Illinois Tollway Base Sheet Revisions

Section M	Base Sheet Drawings		
	Drawing	Modification Summary	Effective: 03-01-2023
	Overhead Sign (OHS)-Series 720		
	M-OHS-729	OVERHEAD SIGN STRUCTURE ITS GANTRY FRAME (STEEL) SINGLE SPAN STRUCTURE DETAILS

VERSION: 2023-03	STANDARD: M-OHS-729	SHEET: 1 OF 8
---------------------	------------------------	------------------

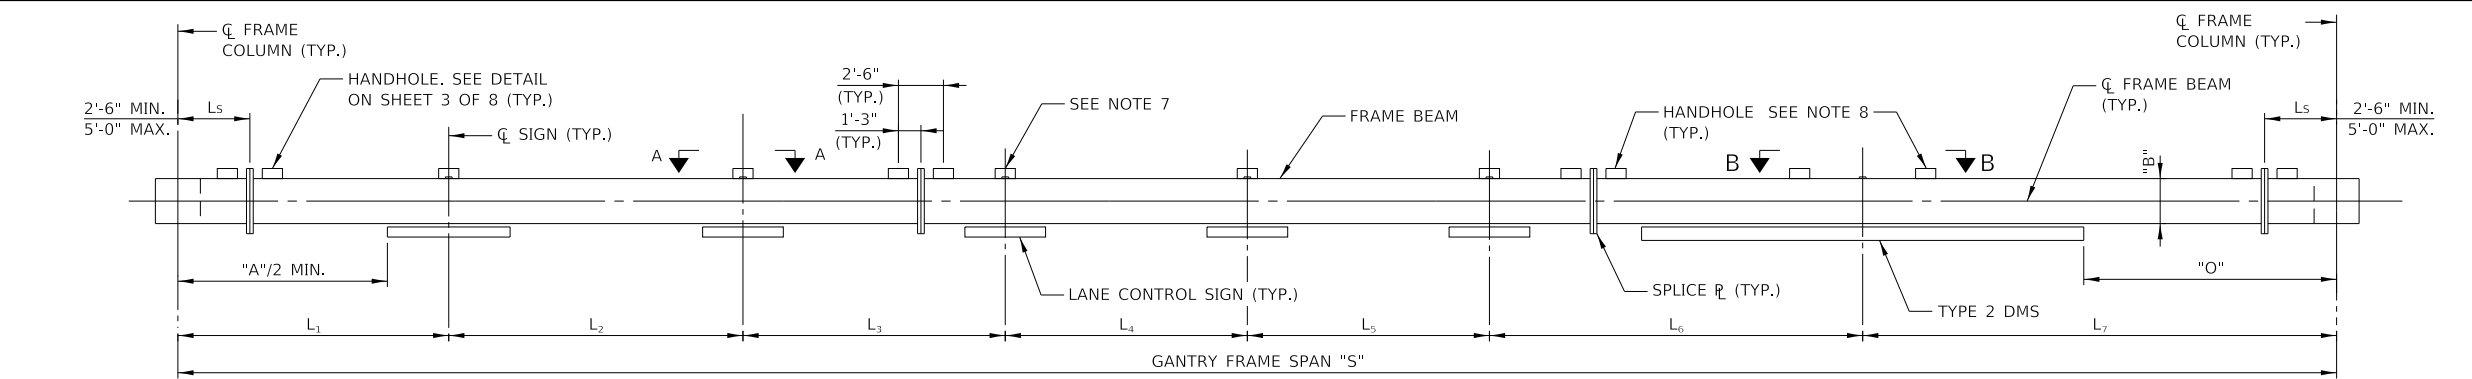
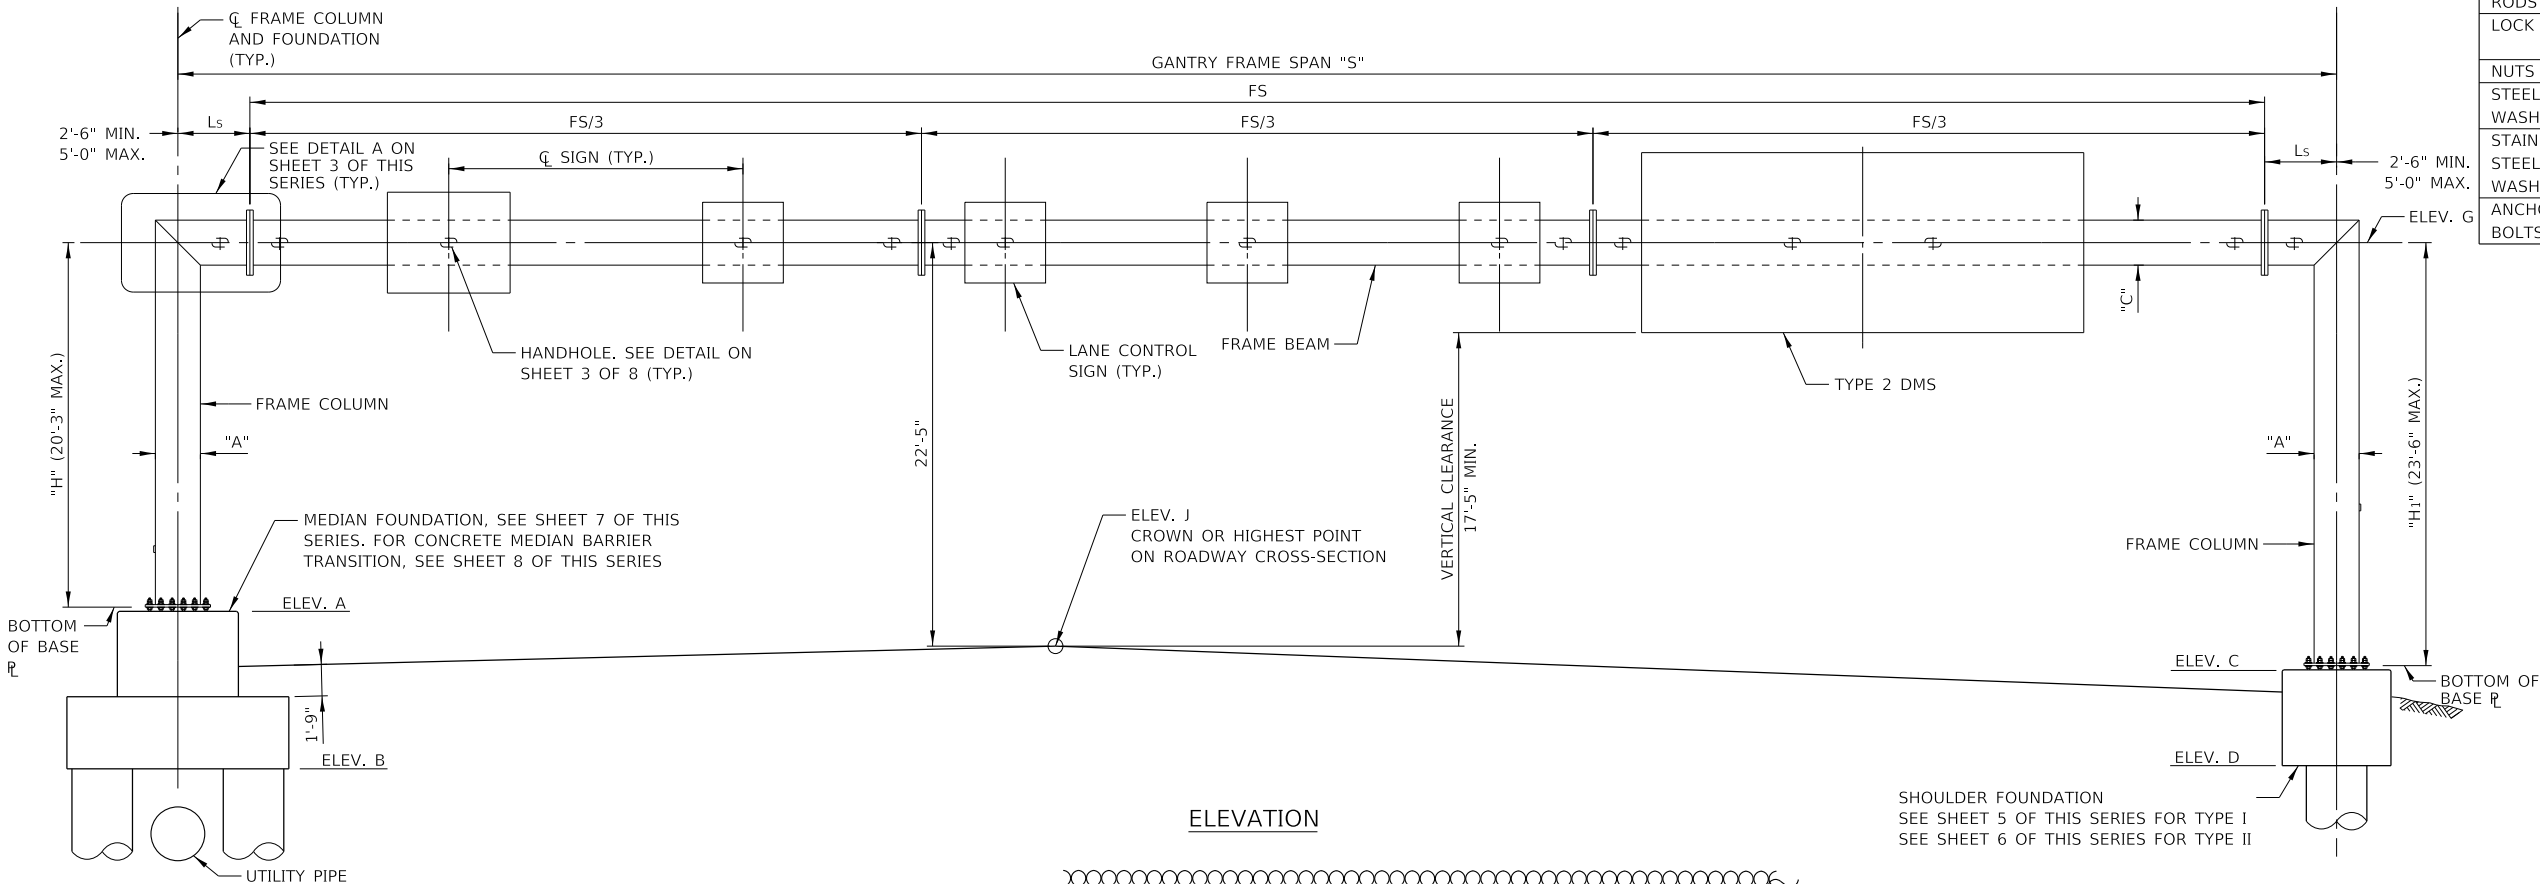
Sheet 1	Revised note to designer to use Type I foundation outside clear zone or behind guardrail.	
		Corrected the thickness and height of gantry frame beams for spans less than 100ft and 100-130ft.

USE SHOULDER FOUNDATION TYPE I WHEN FOUNDATION IS PLACED OUTSIDE CLEAR ZONE OR BEHIND GUARDRAIL.

OVERHEAD SIGN STRUCTURE  
ITS GANTRY FRAME (STEEL)  
SINGLE SPAN STRUCTURE  
DETAILS

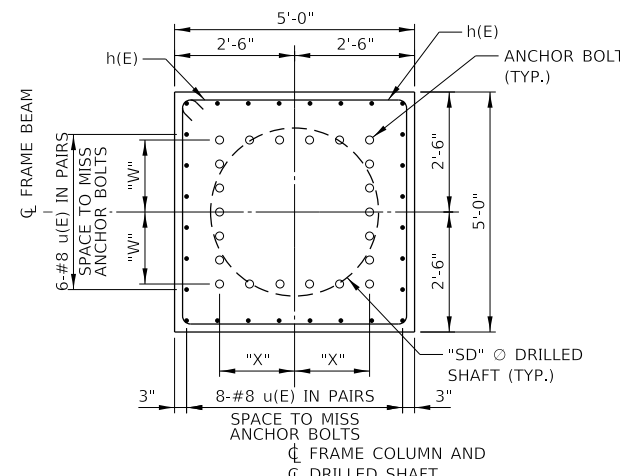
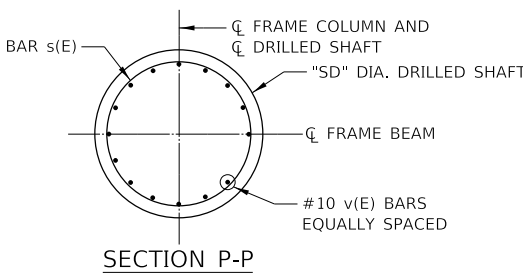
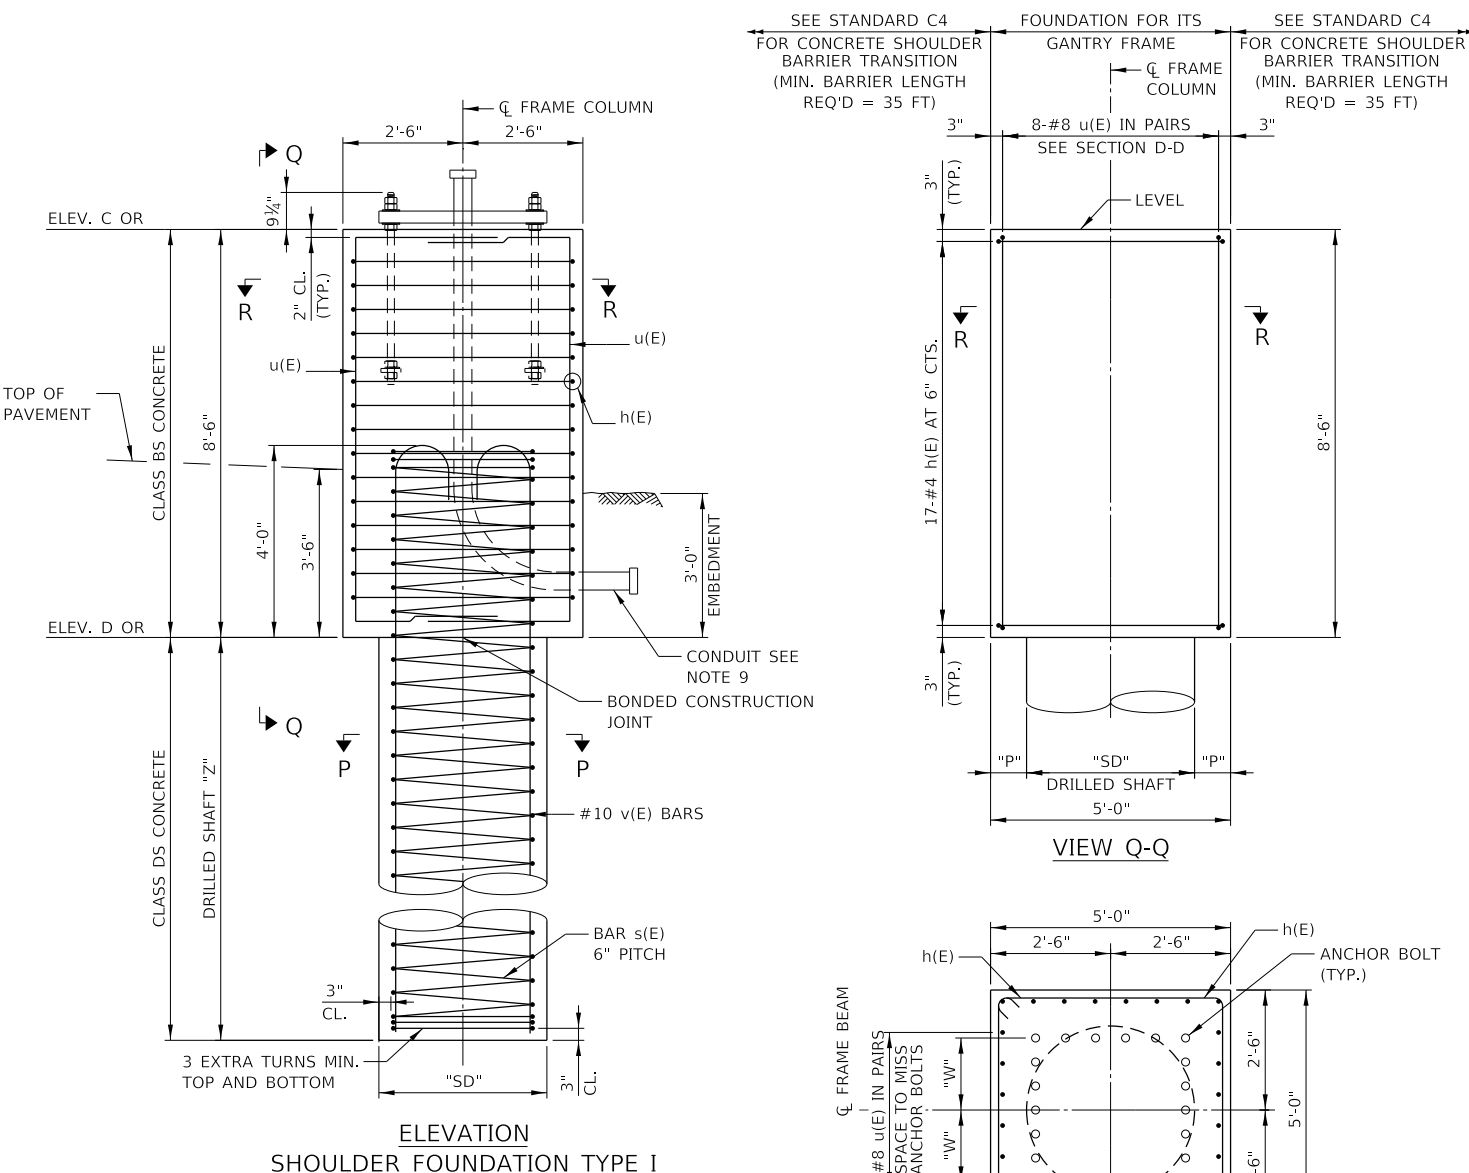
Sheet 6	Revised v(E) bar lengths, updated total bar weights and added note 10 referencing location of "W" and "X" dimensions.	
	Sheet 7	Removed cost included in the cost of "Foundation for ITS Gantry Frame" from note 2.	
		Revised number of of v(E) bars in bar schedule, update reinforcement weight and Section S-S.	
	M-OHS-730	OVERHEAD SIGN STRUCTURE ITS GANTRY FRAME (STEEL) TWO-SPAN STRUCTURE DETAILS

VERSION: 2023-03	STANDARD: M-OHS-730	SHEET: 1 OF 9
---------------------	------------------------	------------------

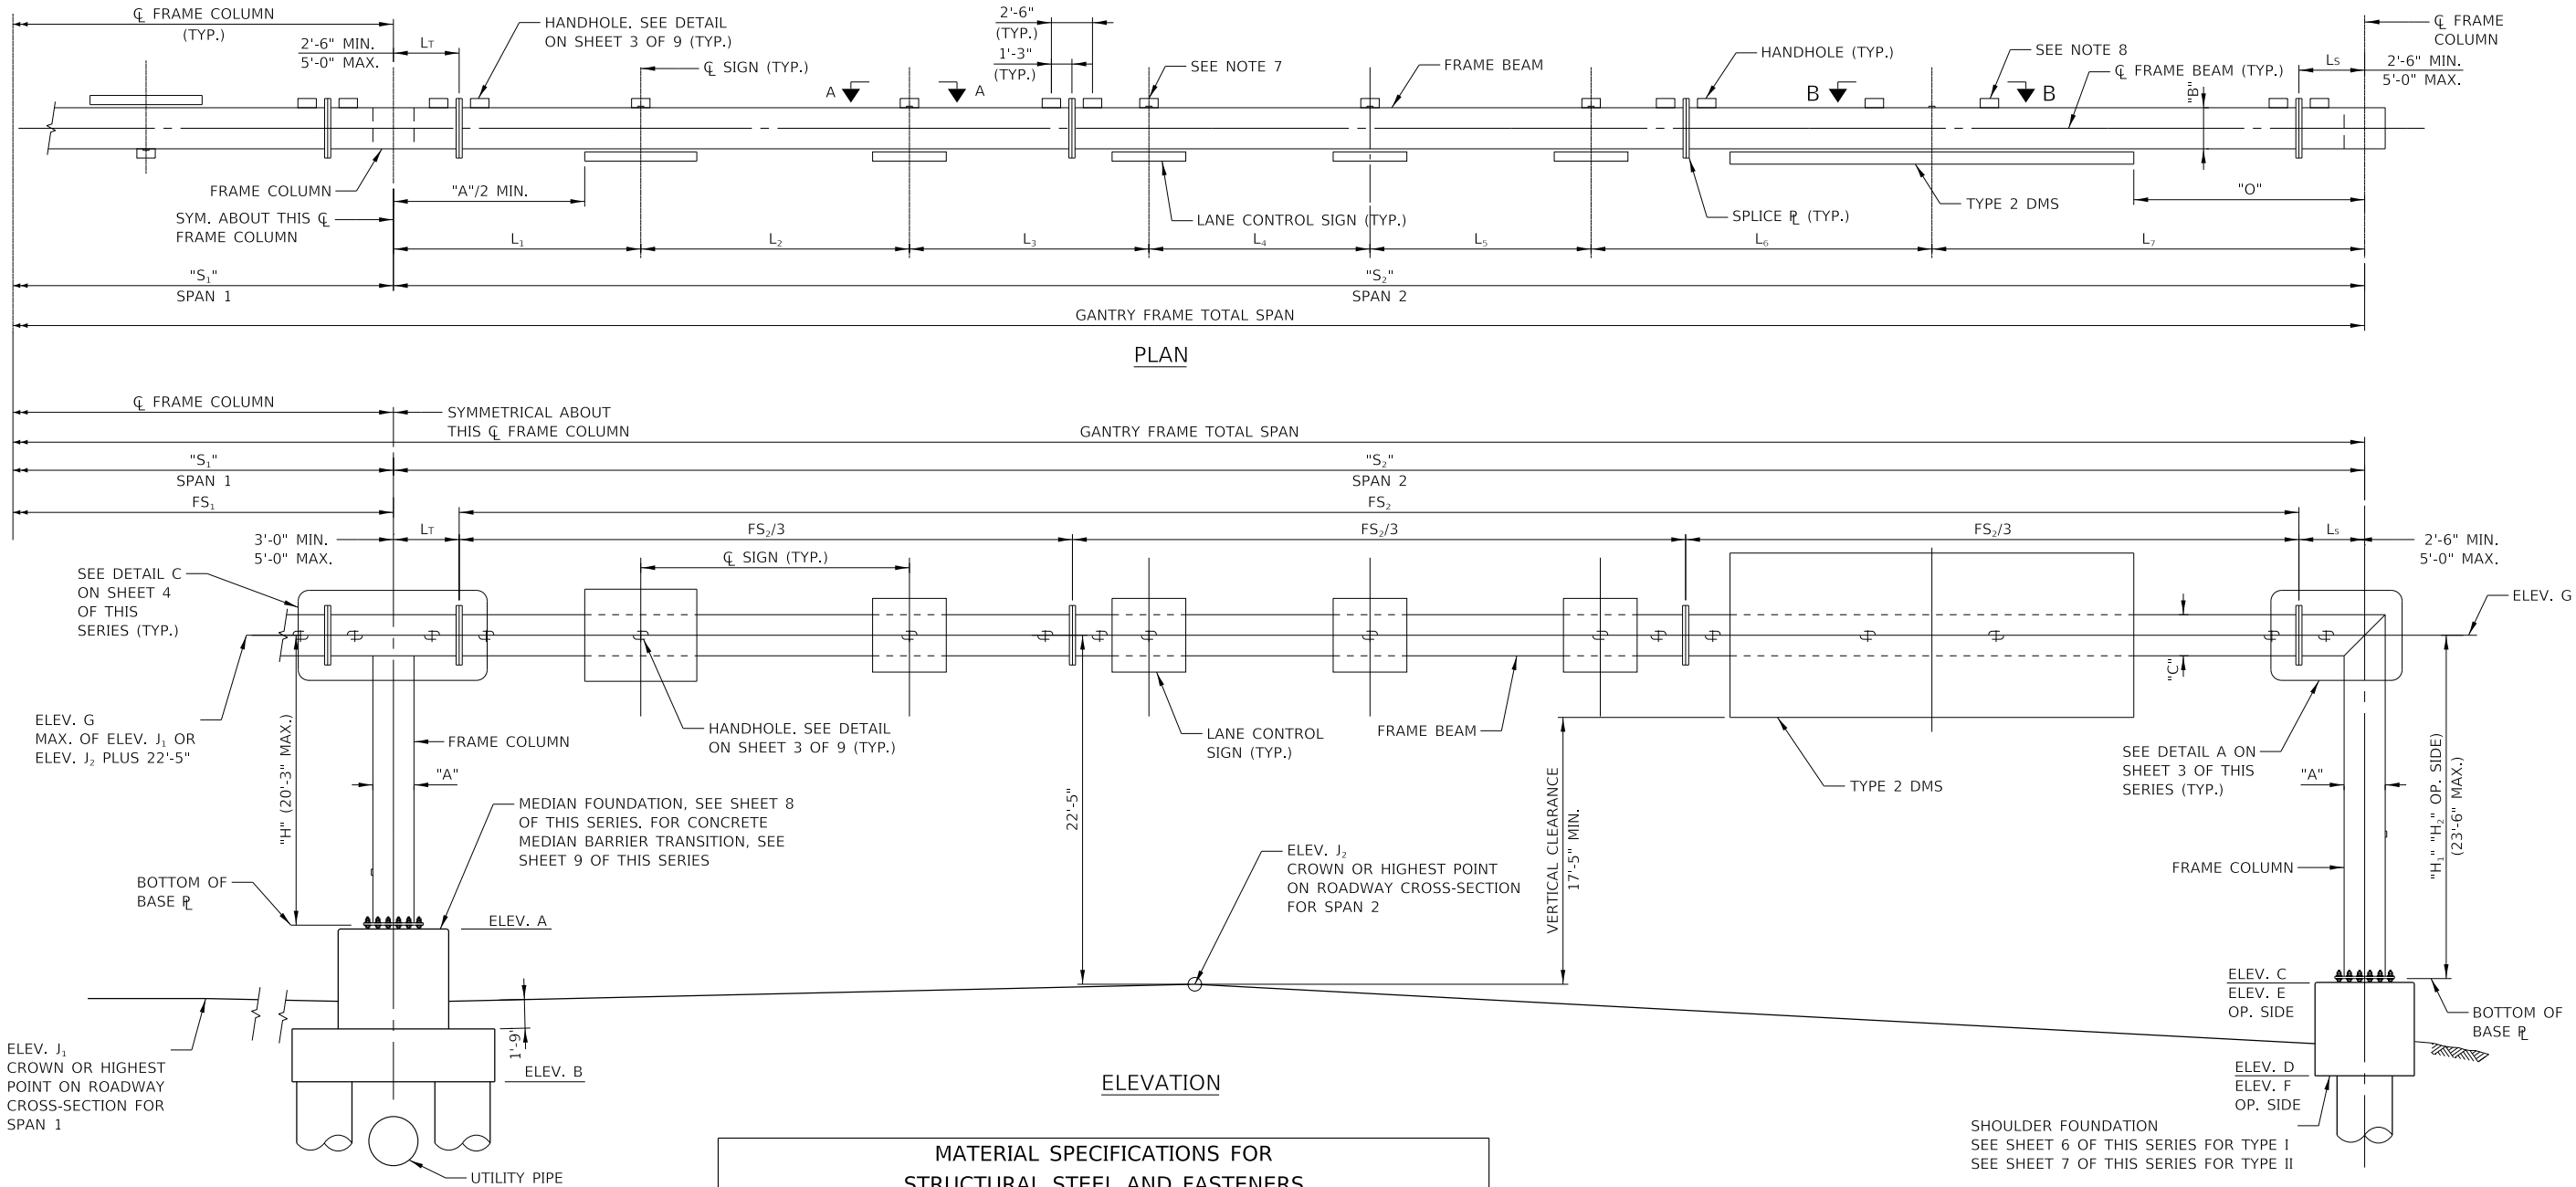
Sheet 1	Revised note to designer to use Type I foundation outside clear zone or behind guardrail.	
		Corrected the thickness and height of gantry frame beams for spans less than 100ft and 100-130ft.

USE SHOULDER FOUNDATION TYPE I WHEN FOUNDATION IS PLACED OUTSIDE CLEAR ZONE OR BEHIND GUARDRAIL.

ELEVATION  
SHOULDER FOUNDATION TYPE I

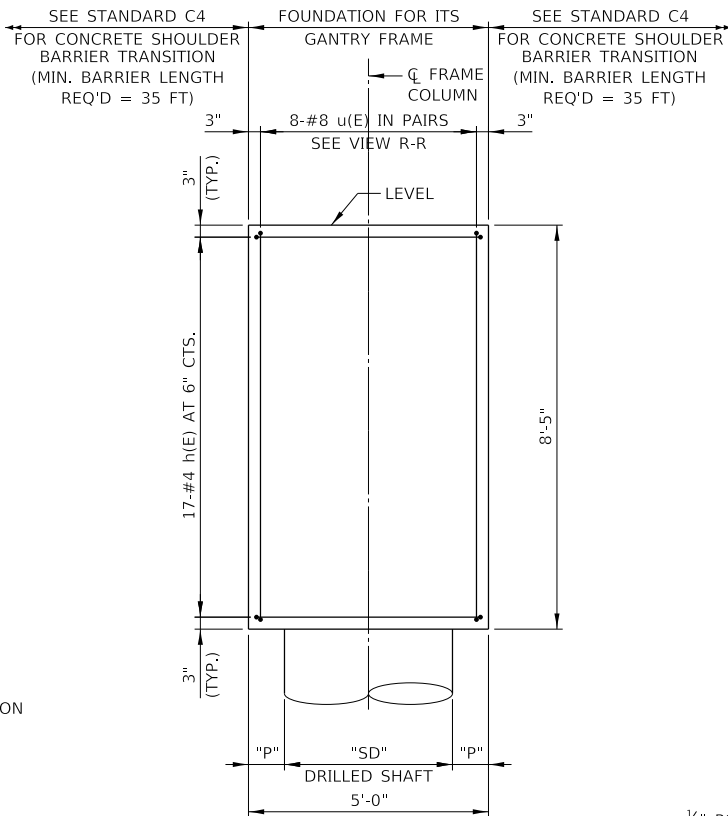
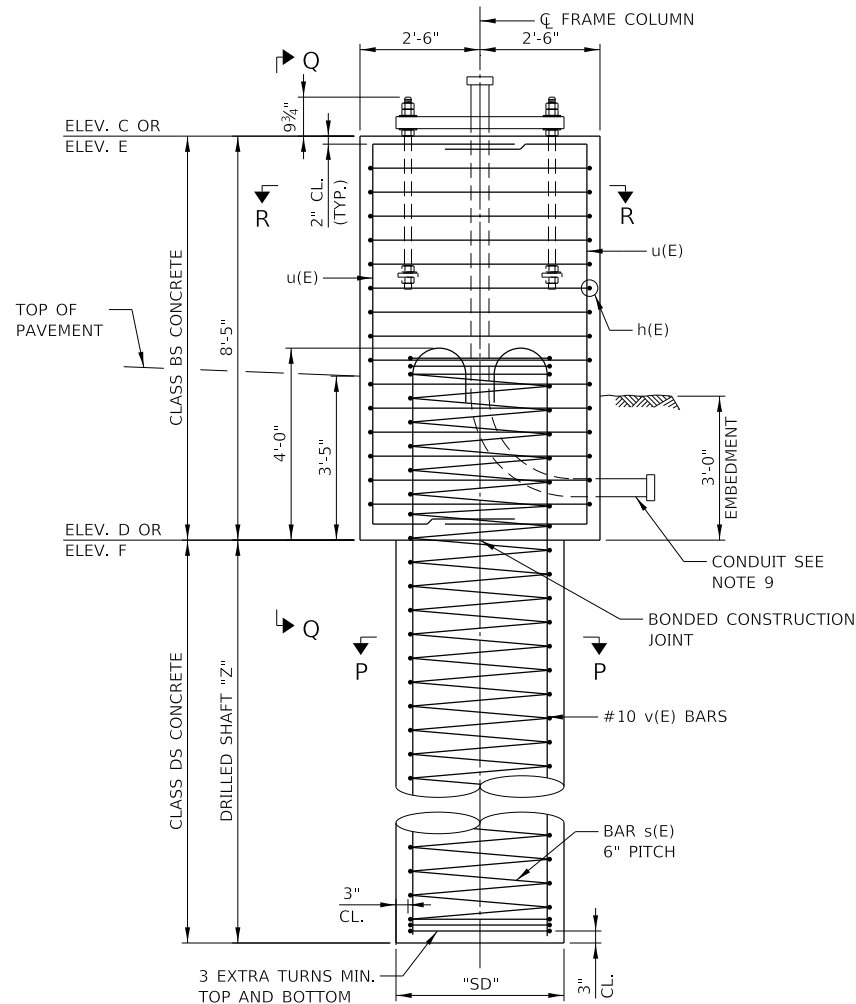
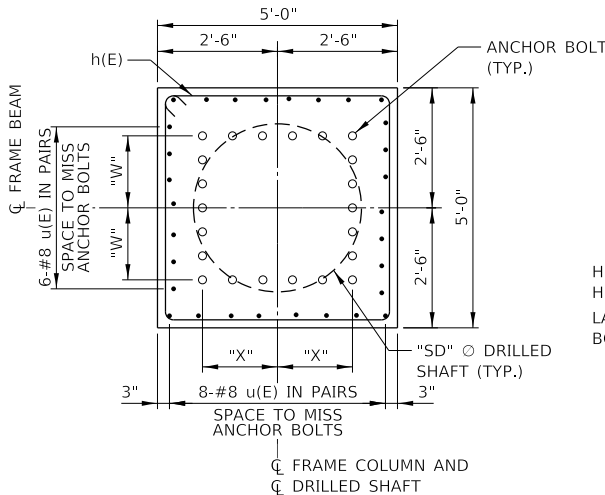
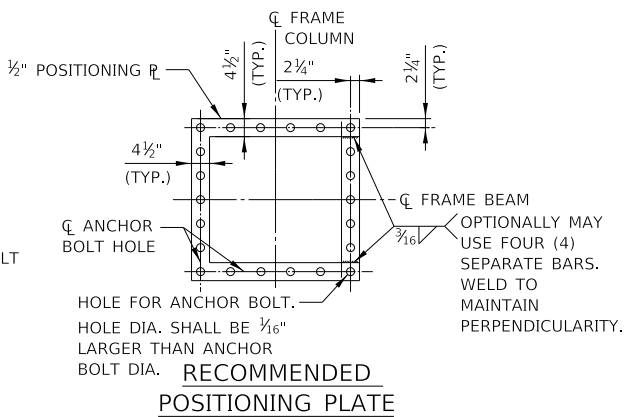
Sheet 7	Revised v(E) bar lengths, updated total bar weights and added note 10 referencing location of "W" and "X" dimensions.		
Sheet 8	Removed cost included in the cost of "Foundation for ITS Gantry Frame" from note 2. Revised number of of v(E) bars in bar schedule, update reinforcement weight and Section S-S.
